# TALLAWONG STATION **PRECINCT SOUTH**

## ADDENDUM URBAN DESIGN REPORT

Rev. C\_08.05.2020

# SITE 1A REFINEMENTS

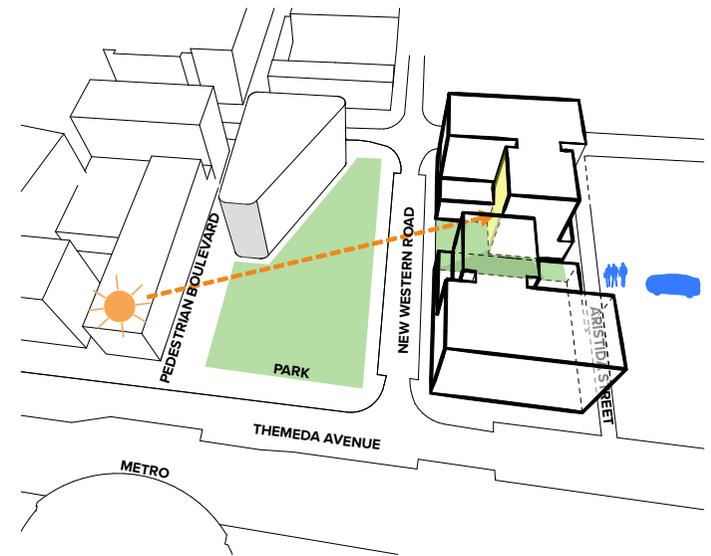
- ✓ Locally shift the built form to maximise solar access to the plaza and building facade
- ✓ Step the built form down to the park and commuter carpark to create a retail podium and provide opportunities for extended outdoor areas above

# SITE 1B REFINEMENTS

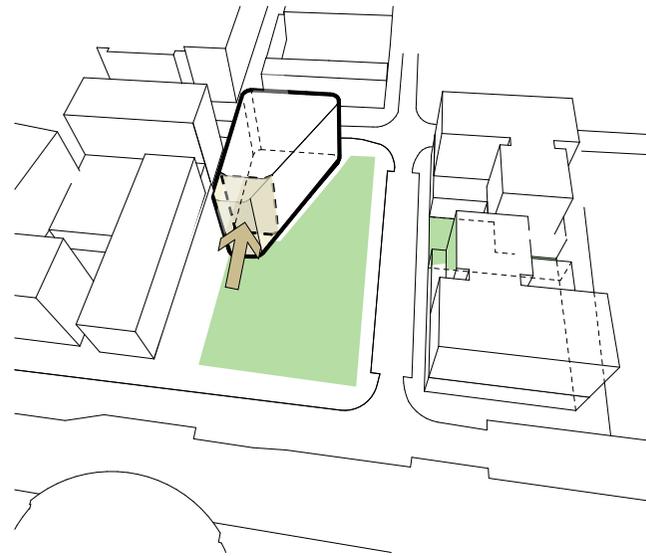
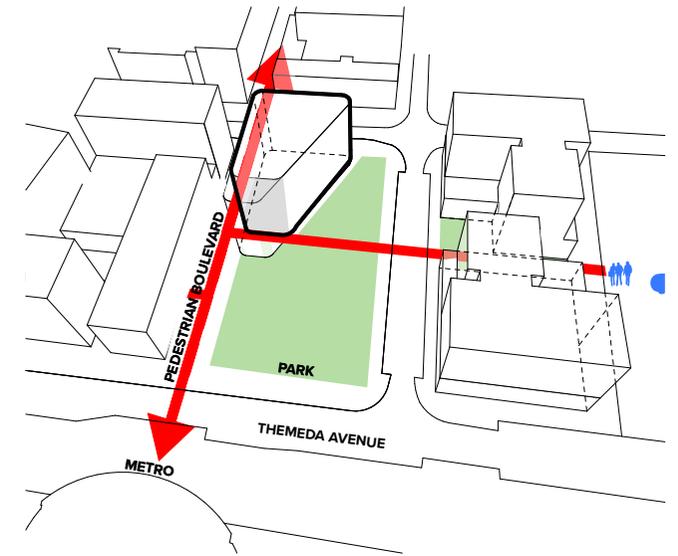
- ✓ Reduce building footprint to object building to provide a direct visual and physical connection to the pedestrian boulevard from commuter carpark, increasing the size of the public park

# SITE 1B REFINEMENTS

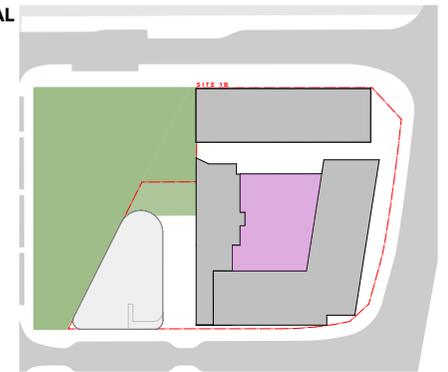
- ✓ Shift building forms to respond to new through site link
- ✓ Reconfigure the built form to define the corner of Cudgong Road and Conferta Avenue, creating a gateway to the residential precinct

# SITE 2C REFINEMENTS

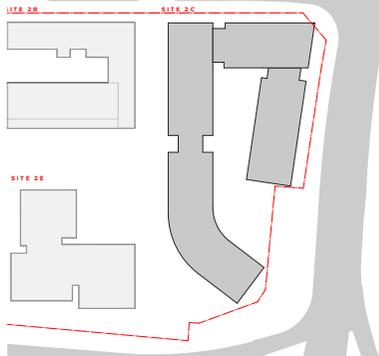
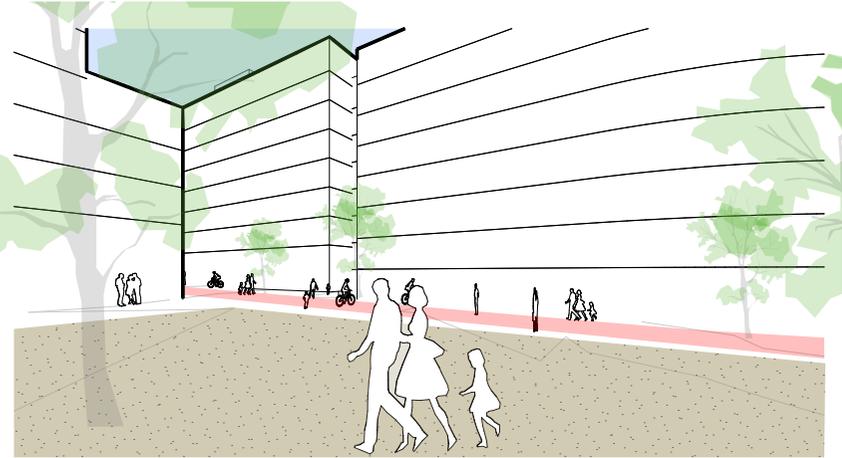
- ✓ Redistribute built form to maximise solar access to shareway/plaza
- ✓ Reduce building lengths to increase visual and physical permeability through the site
- ✓ Redistribute heights to provide a lower scale building interface along the length of the pedestrian boulevard

# SITE 2D REFINEMENTS

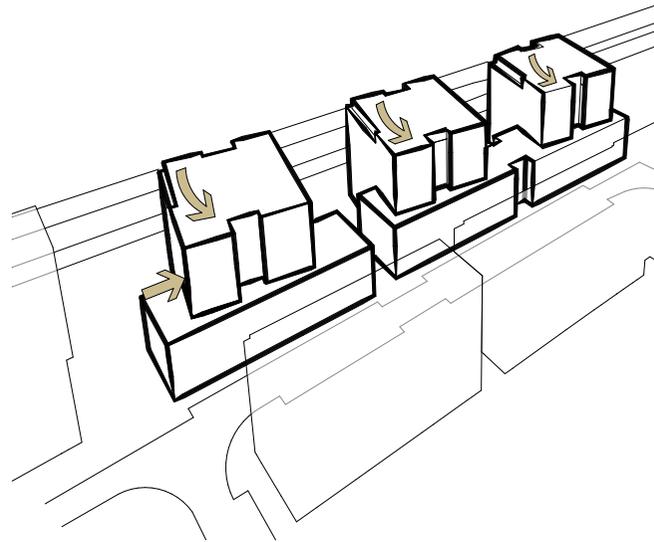
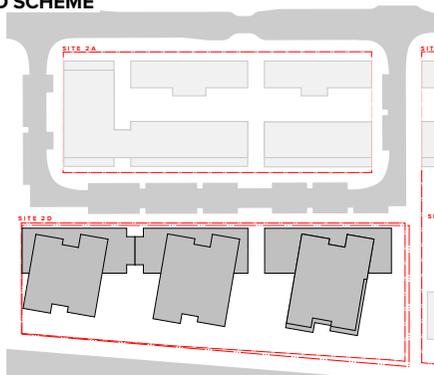
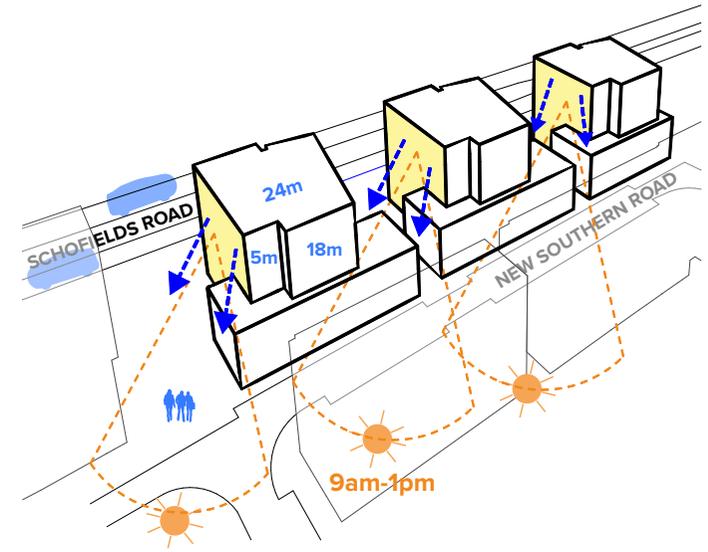
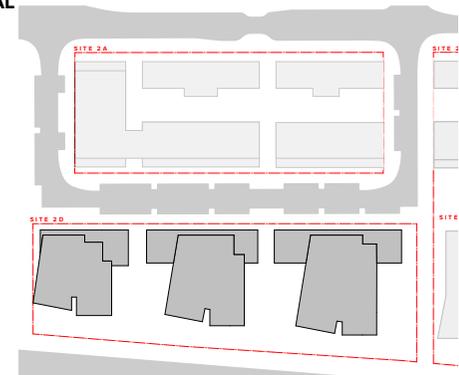
- ✓ Realign facade to orientate outlook north in response to solar access site building alignments
- ✓ Reduce upper building widths to the New Southern Road, increasing separation and outlook from the public domain

# SITE 1B BUILDING HEIGHTS

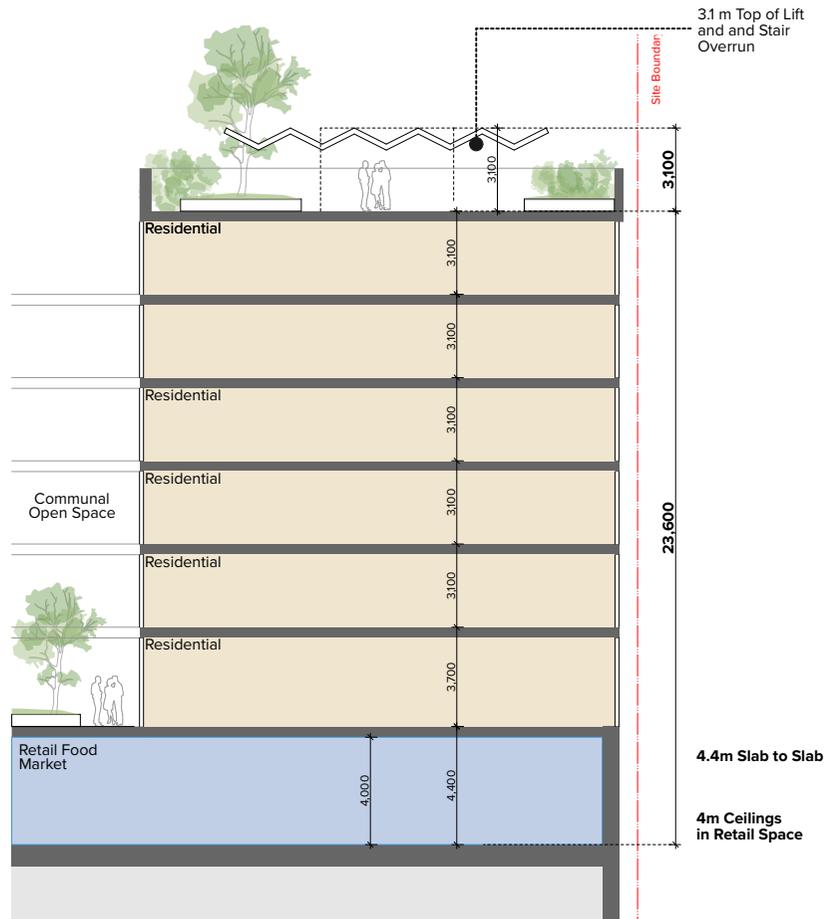
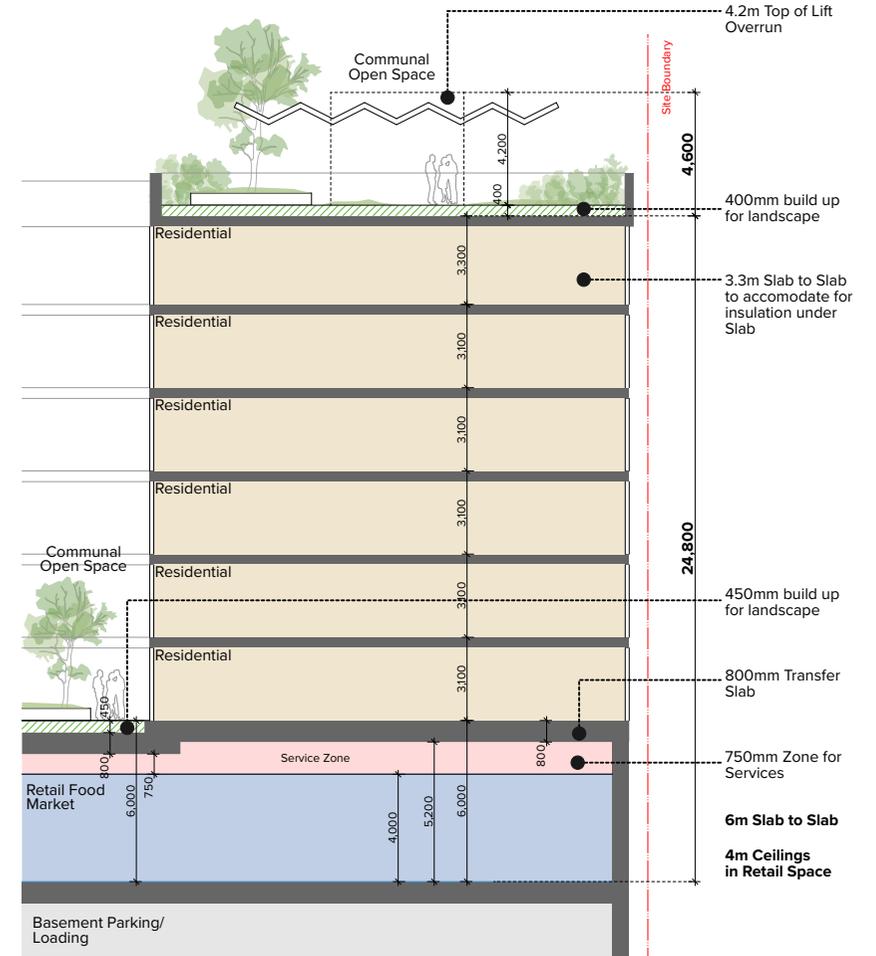
The approved SSDA scheme nominated a 4.0m ceiling height within a 4.4 metre floor to floor height. To accommodate adequate services zones and transfer depths, a floor to floor height of 6.0m is required to achieve a 4.0m ceiling height. This allows for a flexible retail provision that is adaptable to accommodate a number of alternate users over it's life.

Similarly the lift overrun has been assumed at 3.1m above the last level served as opposed to 4.2m which is the average requirement for most lift manufacturers.

These modifications to allow sufficient servicing, circulation and activation of the building marginally increases the heights of the buildings on the primary retail Site 2B.

# SITE 2 BUILDING HEIGHTS

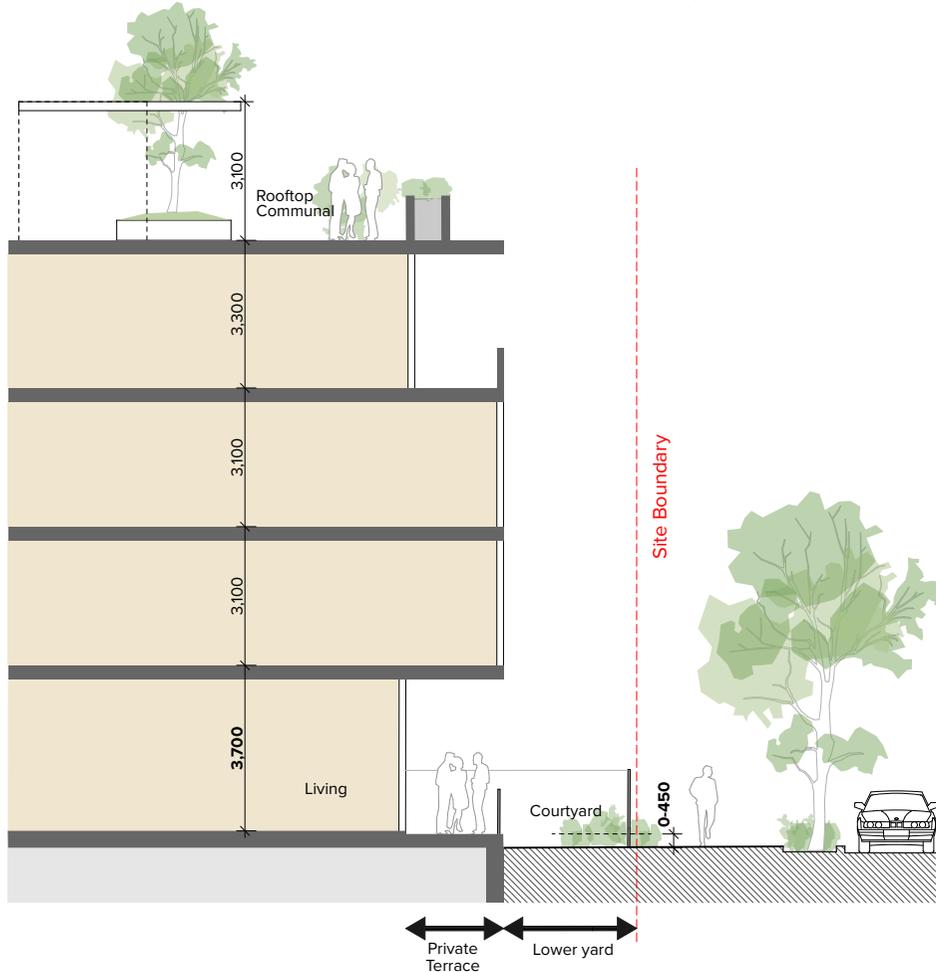
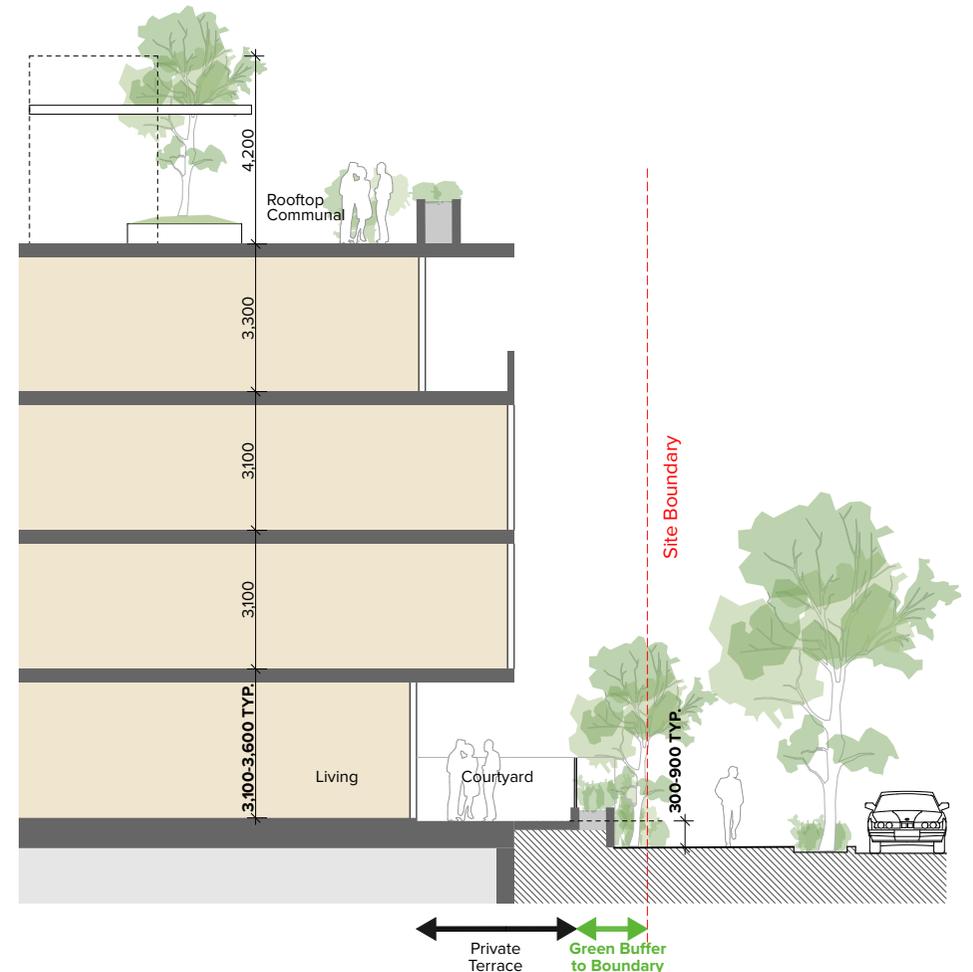
The Approved SSDA allowed for a 3.7m high ground level (floor to floor) to provide an "adaptable residential" level. Given the large provision of non-residential uses (9,000sqm GFA) within Site 1 "Town Centre" it is not considered necessary to provide for future adaptive re-use within the Site 2 "Residential neighbourhood".

Notwithstanding the above, the natural fall of the land allows for a range of heights within the ground plane from 3.1m to 3.6m (floor to floor).

The ground level apartments are proposed to have their floor level set at 300-900mm above the footpath level (typically). The courtyard is proposed to be elevated to provide a consolidated open space, as opposed to the split scenario proposed in the SSDA. This allows for amenity and privacy for residents while maintaining passive surveillance and an active public domain.

The overall height of the building is slightly lower than the SSDA, though the height of the lift overrun has been increased to reflect manufacturers requirements.

# BUILDING HEIGHTS

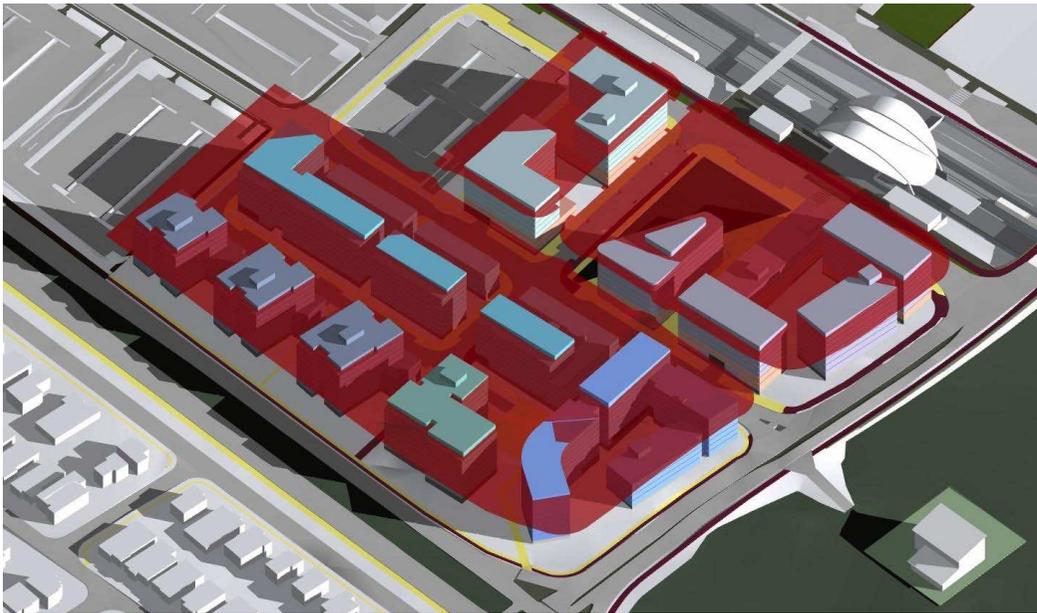
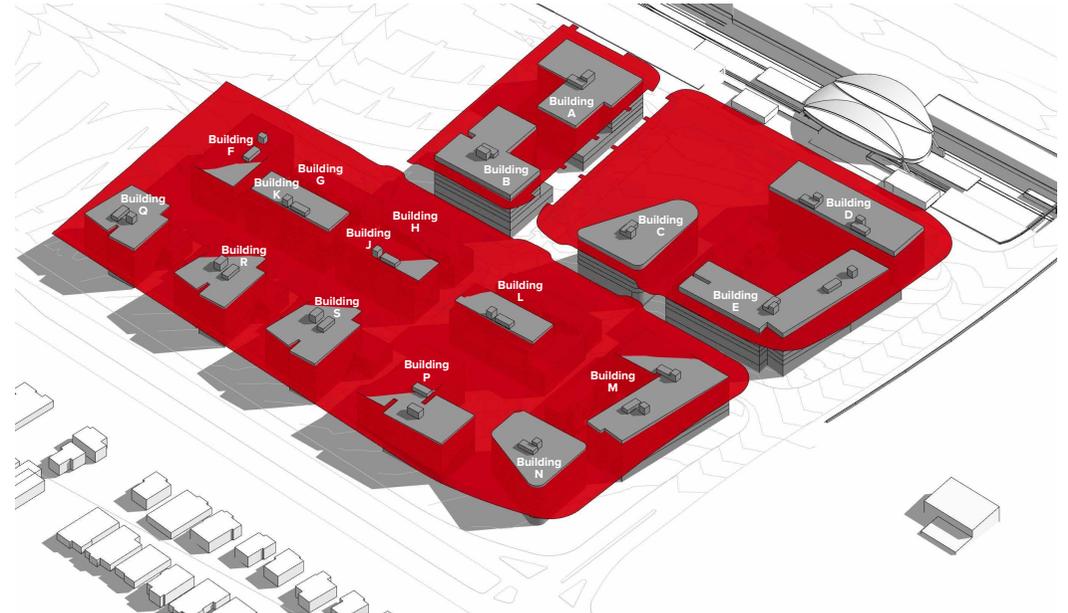
A comparison of the SSDA Approved Scheme and the Amended Proposal shows a minor increase in height to the north of the precinct in Site 1 (to accommodate flexible retail provision), while the buildings to the south of the precinct in Site 2 have a minor reduction in height.

# PRIVATE ROAD DESIGN

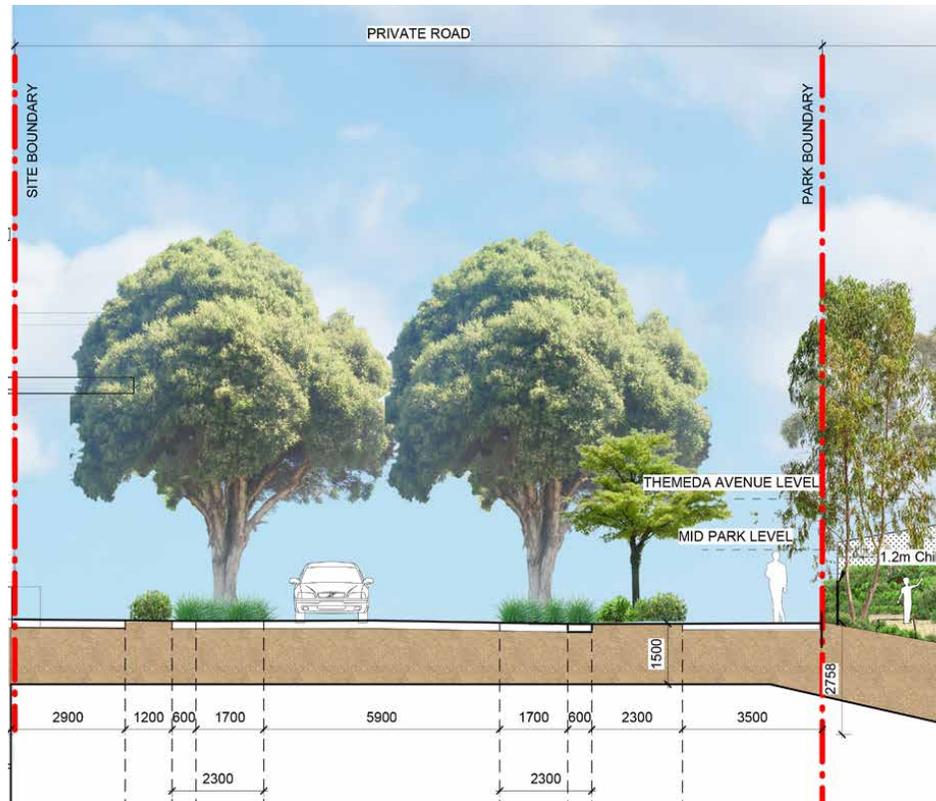
The north-south road has been redesigned with a raised threshold to match the adjacent footpath level, a paved surface treatment with differentiation and delineation of parking bays, and reduced speed limit.

This achieves a significantly improved public domain outcome which prioritises pedestrian primacy, achieves an improved relationship between the eastern and western sides of Site 1, and visually extends the perceived size of the park.
